**From:** [MH Specter](#)  
**To:** [Buckberg, Perry](#)  
**Subject:** [External\_Sender] NRC's Memorandum and Order CL1-21-01  
**Date:** Saturday, March 06, 2021 12:03:16 PM  
**Attachments:** [Critique of NRC's Memorandum and Order CLI-21-01.pdf](#)  
[EXECUTIVE SUMMARY Critique .pdf](#)

## **Critique of the NRC's Memorandum and Order CLI-21-01**

# CRITIQUE OF NRC'S MEMORANDUM AND ORDER CLI-21-01

Nuclear Regulatory Commission Memorandum and Order CL1-21-01 denied all requests for a hearing and all petitions to intervene in the matter of decommissioning the Indian Point (IP) nuclear power facility. The NRC rightfully enjoys a very high reputation for its technical work, but the NRC Indian Point decommissioning Safety Evaluation (SE) and this Memorandum and Order are well below this standard. This Memorandum and Order puts New Yorkers at risk.

FIGURE A-1 Cumulative Savings at IP2 Based on HDI Data, \$ in Millions

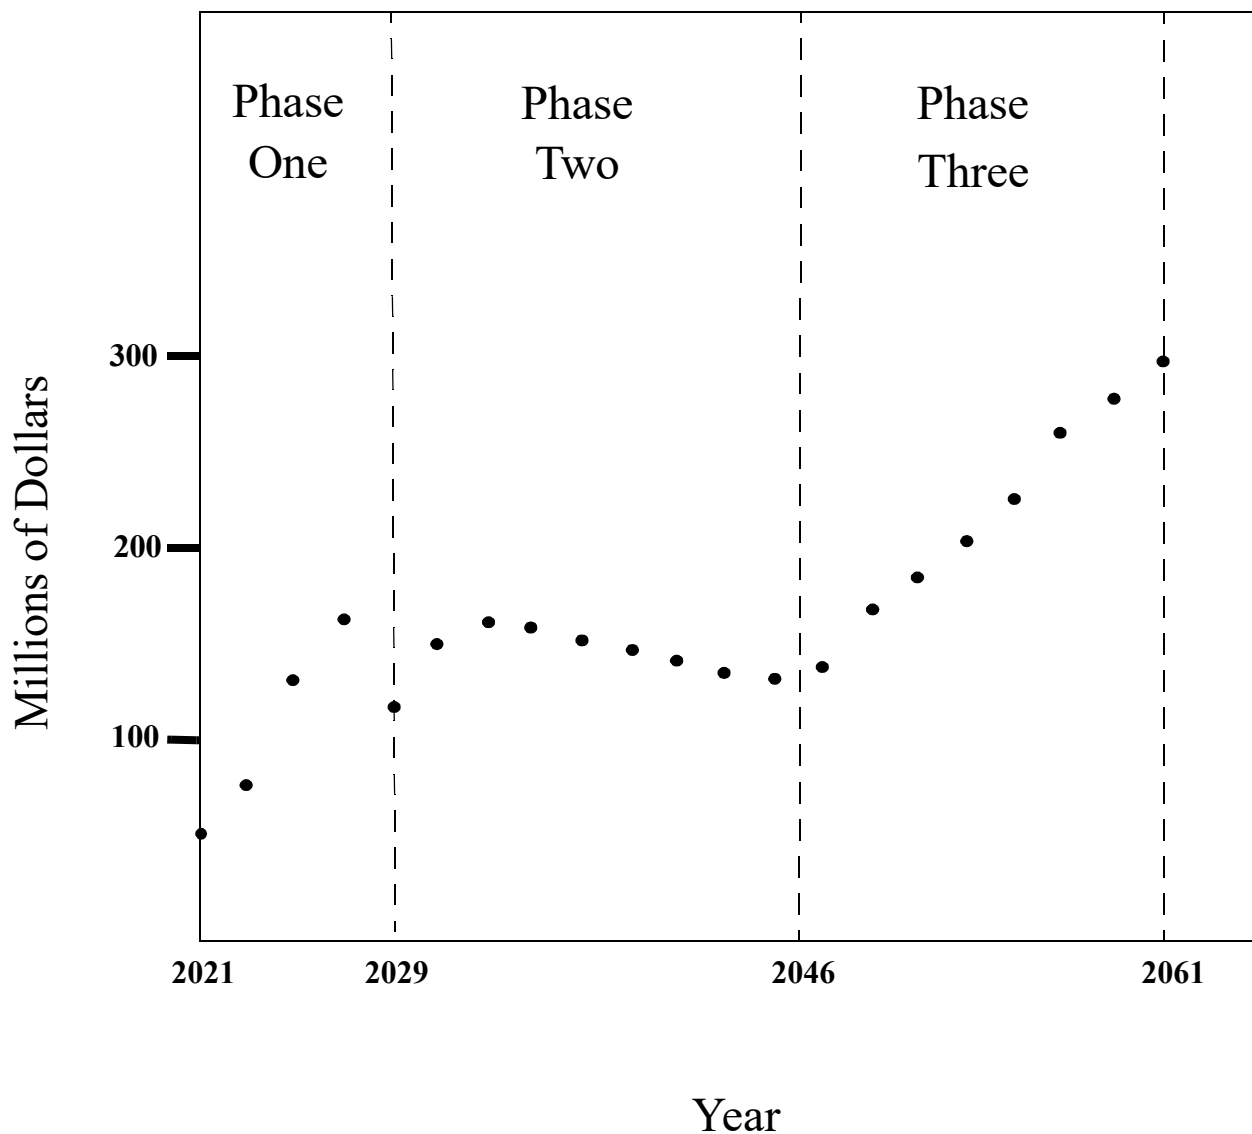
As of October 30, 2019, the Indian Point 2 DTF that was smaller than the IP3 DTF by \$262 million dollars. Nonetheless, HDI claims it can decommission IP2 for \$301 million dollars less than what it costs to decommission IP3, and end up with a surplus of \$72.7 million dollars. A review of the HDI PSDAR did not provide support for this claim. Nor was there a detailed accounting for this large cost difference provided in the SE. The NRC requested additional information (RAI) on this topic from HDI, but neither this RAI nor HDI's responses have been fully shared with the public. When the SE listed potential IP2 cost savings relayed to the NRC staff by HDI, it did not quantify what each of these claimed savings were or if the total savings accounted for the \$301 million dollar difference. This critique refutes all of the claimed IP2 savings listed in the SE.

The HDI claim that it can decommission IP2 for \$301 million dollars less than it takes to decommission its sister plant, IP3, defies common sense. It is also inconsistent with HDI's PSDAR and other HDI documents. No other site in the entire USA that has sister PWRs on it has produced significantly different decommissioning costs from one unit to another. Further, the NRC has estimated radiological decommissioning costs for many pairs of PWRs on the same site and has published these results in SECY-18-0078. The NRC did not identify large cost differences between any pairs of PWRs in this SECY report. The NRC also made radiological decommissioning cost estimates specifically for IP2 and IP3 and they are identical. The HDI claim of large savings between IP2 and IP3 is unique.

FIGURE A-2 HDI’s Decommissioning Schedule

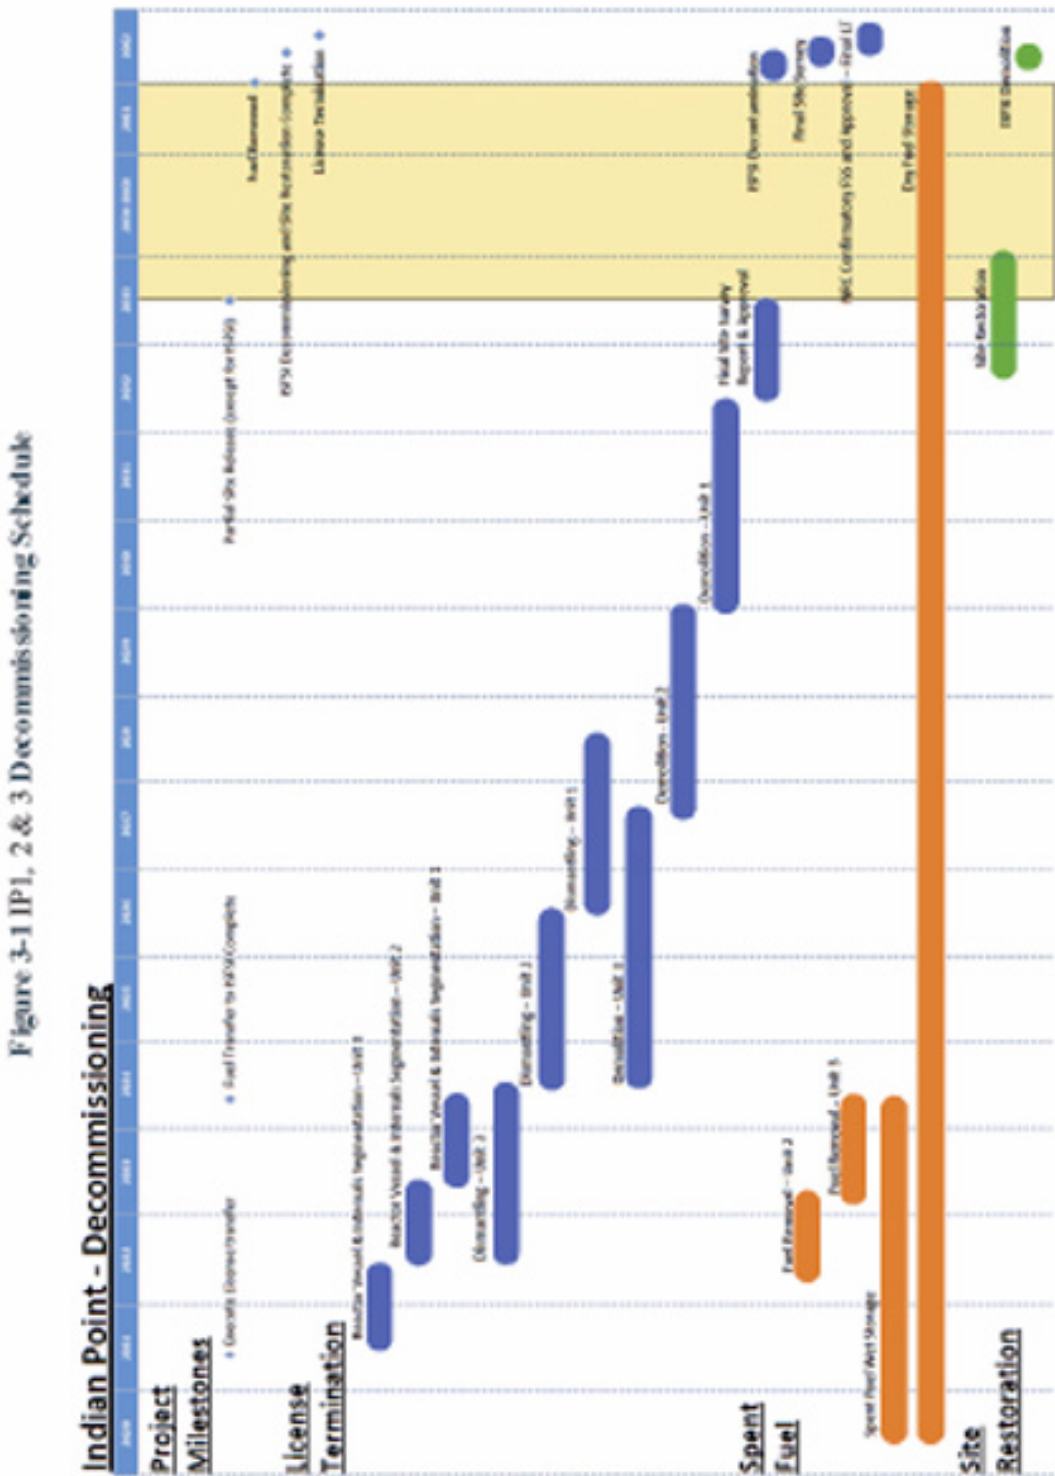
Over the span of forty years, many tasks will need to be carried out. The nature of these tasks will vary significantly from major physical actions like reactor vessel and internals undergoing segmentation and containment building demolition in the first 12 years, to far fewer active events in later years when there are tasks like site surveys and report writing. Therefore the uncertainty components that were considered in the generation of the 18% Contingency Allowance, at an 85% confidence level, will change over time. Because the design of IP1 differs from the design of IP2 and IP3, it has its own set of uncertainties. It seems appropriate for HDI to set an 18% Contingency Allowance but inappropriate to claim that this 18% Contingency Allowance will be fully consumed for each and every task, year after year. When HDI issued its PSDAR on December 19, 2019 it had no way of knowing which situation dependent events would occur in the future, their costs, and which ones might fully consume the Contingency Allowance. From a public protection point of view, all unused monies in the Contingency Allowance should be returned to the respective DTFs. This return of unused monies should be done task by task and closely monitored by independent inspectors. All of the above HDI issues have this in common: they work to HDI's benefit.

FIGURE A-4 Contingency Allowances

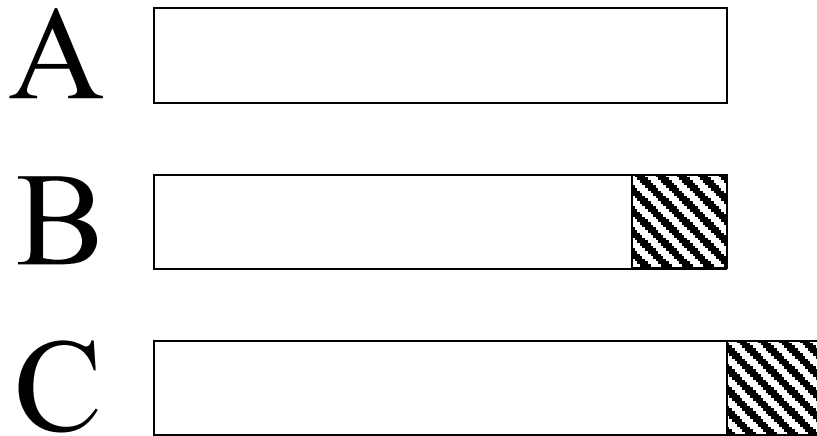
Figure A-3 was generated to further examine the meaning of the above HDI statement. The striped area represents the 18% contingency allowance. AREA A in Figure A-3 represents this best estimate cost. Area B shows the Contingency Allowance as an integral part of the cost to complete the IPEC decommissioning. Areas A and B are drawn to be the same size, i.e., they both have the same cost to complete the task at hand. However, unless one assumes that the Contingency Allowance was set to zero, i.e, did not exist, AREA B is unworkable. AREA B is unworkable because in order to make the Contingency Allowance and integral part of the cost, the best estimate part would have to shrink. But there cannot be two different best estimates. If AREAS A and B are the same size, then HDI's statement about the Contingency Allowance being an integral part of the cost appears to be illogical.

From a public protection point of view it would be prudent to assume that the Contingency Allowance is best represented by Area C where the Contingency Allowance lies outside of the best estimate and is available to deal with the inherent uncertainties HDI describes, and that all unused money is returned to the sponsoring DTF once the task is completed. TABLE A-4 lists the dollar impact of having an 18% Contingency Allowance to supplement the best cost estimate.
